MASSEY - PHASE 2

GRADING & DRAINAGE AND UTILITY PLAN

MASSEY - PHASE 2

GRADING & DRAINAGE PLAN

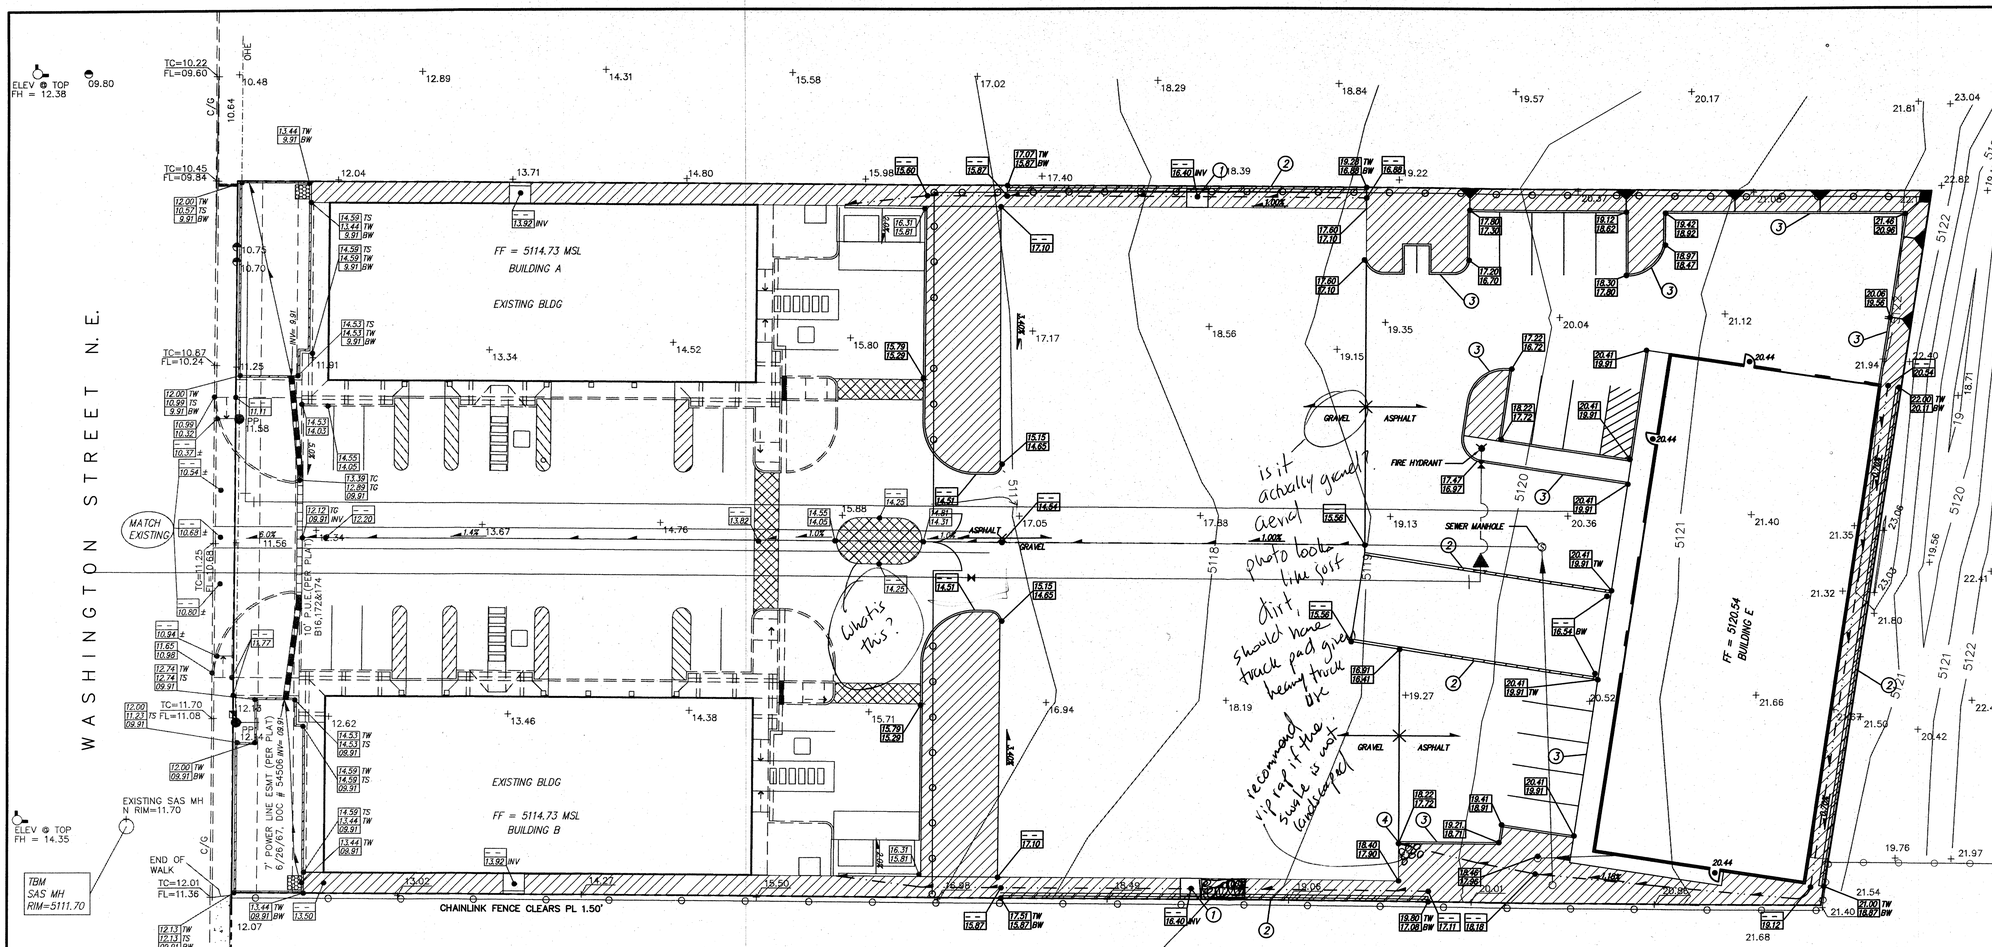
Place rip rap to mitigate clogging of the sidewalk pipes.

THE INTENT OF THIS PLAN IS TO MAINTAIN THE SAME DRAINAGE PATHS FOR THE PROJECT SITE AS DETERMINED FROM HISTORIC CONDITIONS AND EXISTING TOPOGRAPHY. THE SITE WILL BE GRADED TO DIRECT FLOWS TO THE PONDS WEST OF THE SITE. THE EXISTING PONDS HAVE BEEN SIZED FOR FULL BUILD-OUT AND WILL SERVE AS A DETENTION POND. THE PONDS WILL RELEASE THE FULLY DEVELOPED FLOWS AT THE HISTORIC RATE. THE STORM WATER WILL BE RELEASED AT THE NORTHWEST CORNER OF THE NORTHERN MOST DETENTION POND AT A MAXIMUM RATE OF 6.02 CFS THROUGH A 0.7 FOOT OPENING IN THE WALL OF THE DETENTION POND. THE RUNOFF WILL THEN DISCHARGE INTO WASHINGTON STREET WHICH DRAINS TO THE ALAMEDA STORM DRAIN, THAT IS SIZED FOR THE 10 YEAR STORM. THE SAME POND WILL HAVE ENOUGH VOLUME TO RETAIN THE "FIRST FLUSH". which is how much?

The invert of the outfall is set at the bottom of the pond, it's not actually retaining any volume, other than a minimal amount of infiltration due to flat slopes.
